**BEFORE THE PUBLIC UTILITY COMMISSION
OF OREGON**

Docket No. LC 82

PACIFICORP, dba PACIFIC POWER,

2023 Integrated Resource Plan.

Figure 1. Difference in Installed Cumulative Capacity Between 2023 IRP Preferred Portfolio and Current Reality

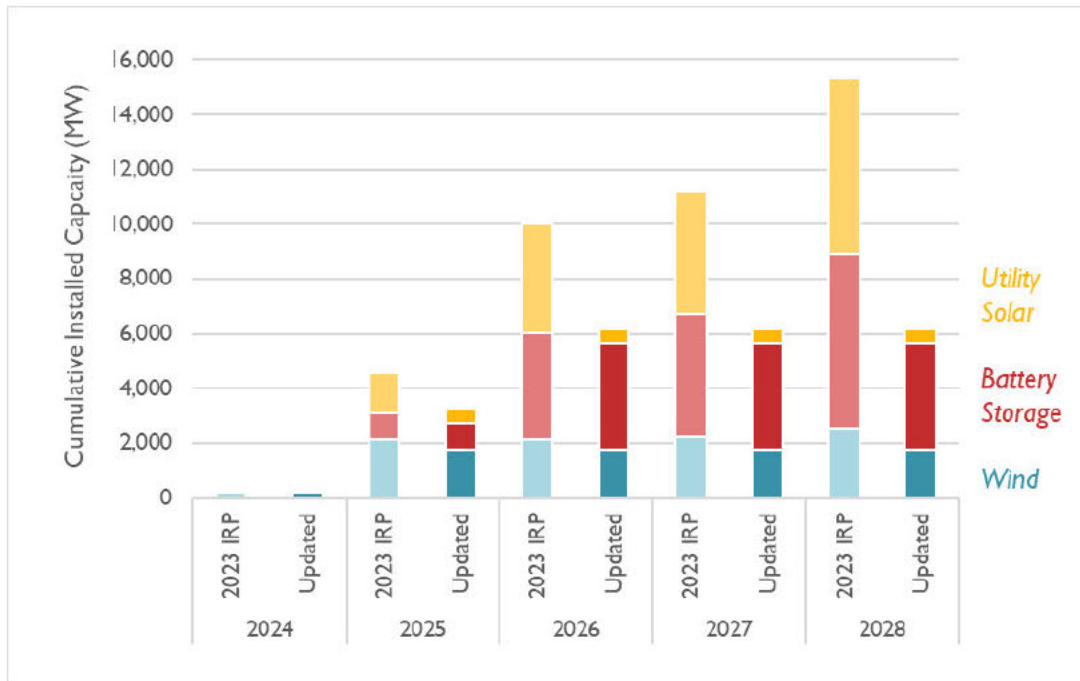
The figure below demonstrates the impact that this delayed procurement could have on renewable resource builds over the next five years. The “2023 IRP” chart series on the left represents the data as presented in the Preferred Portfolio. The “Updated” chart series on the right represents capacity that PacifiCorp has currently indicated it can procure based on the 2020AS RFP and bilateral storage contracts. Solar is the resource that is most at risk due to the 2022AS RFP suspension, as the 2020AS RFP did not result in a large number of solar additions and PacifiCorp has not indicated any alternative procurement processes for solar.

Figure 2. Reproduction of Figure 9.60 in IRP, with and without 2022AS RFP Suspension Impacts

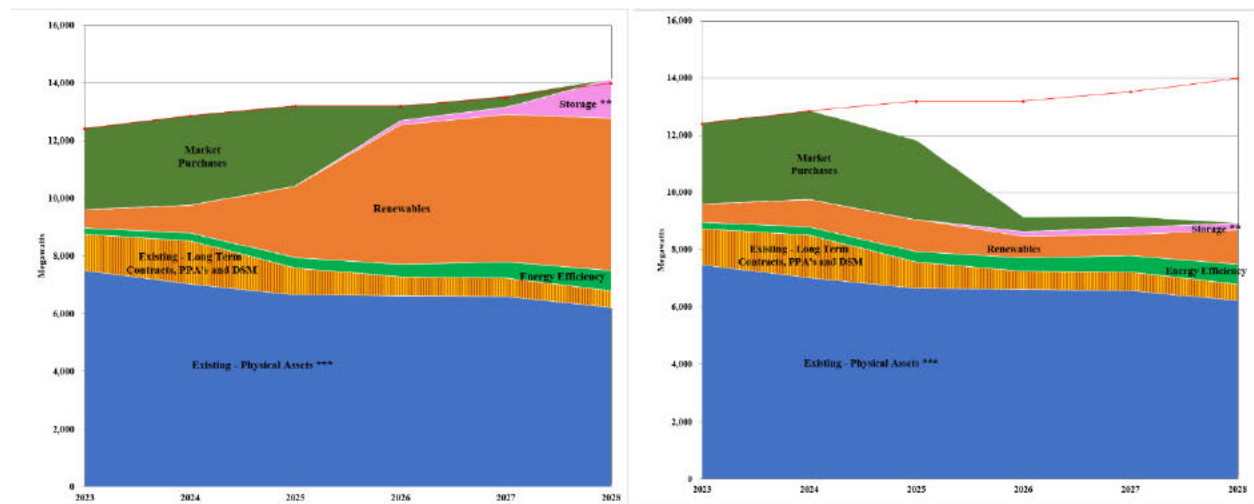
This delay will also have a significant impact on the generation mix of the system. Figure 9.60 in the IRP shows the projected generation by resource type for the Preferred Portfolio. Over the next five years, PacifiCorp’s Preferred Portfolio relied heavily on market purchases (also referred to as front office transactions or FOTs) and existing resources in the near-term while transitioning to rely more and more on new renewable resources. The left side of the figure below is a reproduction of Figure 9.60 as published in the IRP for years through 2028. The right side of the figure below demonstrates what the generation mix could look like if PacifiCorp does not procure new renewables and instead has a capacity mix that resembles the “Updated” chart series in Figure 9 above.

Without the guarantee of additional solar, storage, and wind resources coming online over the next few years, PacifiCorp may end up relying more heavily on FOTs or delaying thermal resource retirements relative to the Preferred Portfolio. This could lead to decarbonization risks, which the Company has not adequately addressed in the current IRP.

Figure 8: 3Comparison of Forecasted v. Actual Coal Use as Percent of Generation

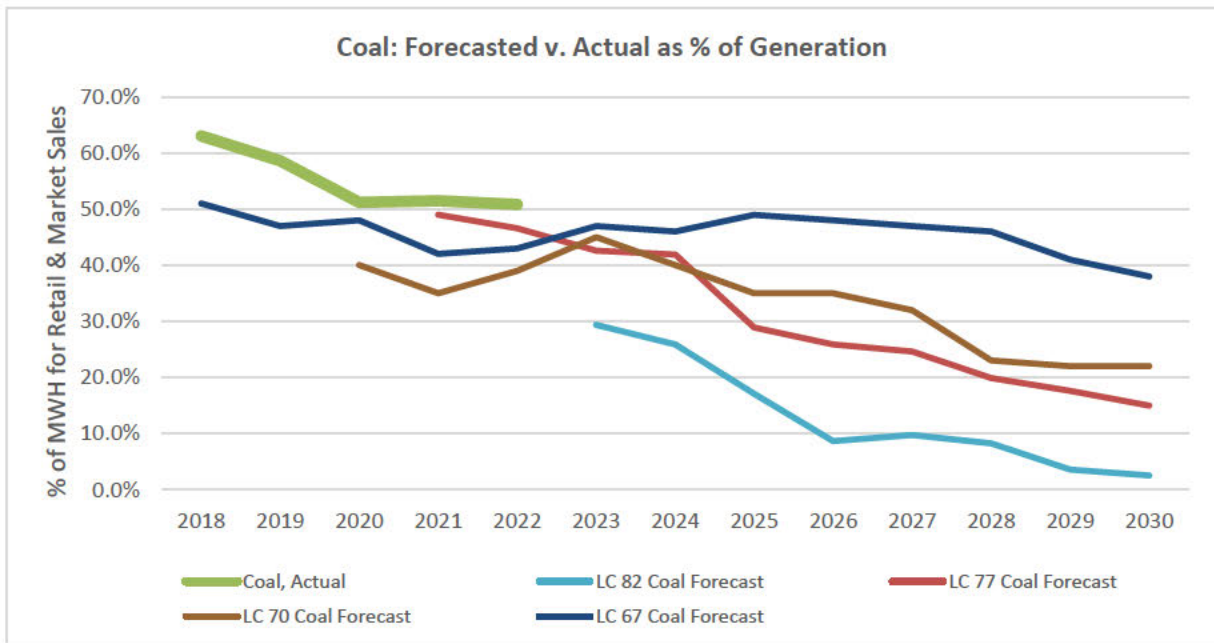
Staff conducted a brief analysis forecasted to actuals in an attempt to substantiate CUB’s comments regarding the disconnect between planning that uses a carbon price and actual coal operations.

Staff’s simple analysis would seem to corroborate CUB’s concerns regarding the realism of PacifiCorp’s modeled coal dispatch in the IRP. Staff raised a similar concern in UM 2225 in discussing the role of

Figure 9: Mid-term DRI Hours and Magnitude for the Western Interconnection

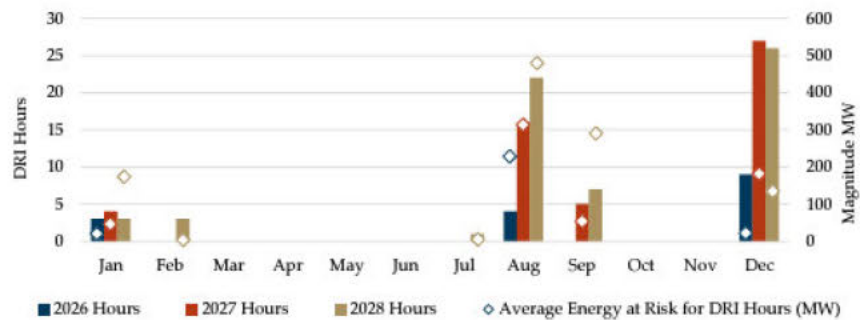
The WARA finds that a significant increase in Demand at Risk hours in December can be attributed to increased load forecasts in the Northwest, while there are relatively few utility-scale resource additions planned in the Northwest. The WARA concludes that load serving entities may need to delay resource retirements if they cannot mitigate these risky hours in the next two years. However, we note that WARA may have less visibility into local small-scale supply and demand resource activity that could reduce the at-risk hours in those out years.

Notably, PacifiCorp’s IRP relies on 944 MW of summer market purchases in 2027 and 493 MW in 2028.¹³⁴ Given WECC’s showing of regional resource adequacy risk during August in those years (red bars in Figure 4 above), the expectation of nearly 1 GW of market energy being available for purchase during summer peak hours seems potentially risky. Further, PacifiCorp has suspended the 2022AS RFP that would have brought resources online from 2025 through 2027, further increasing the region’s resource adequacy risk.
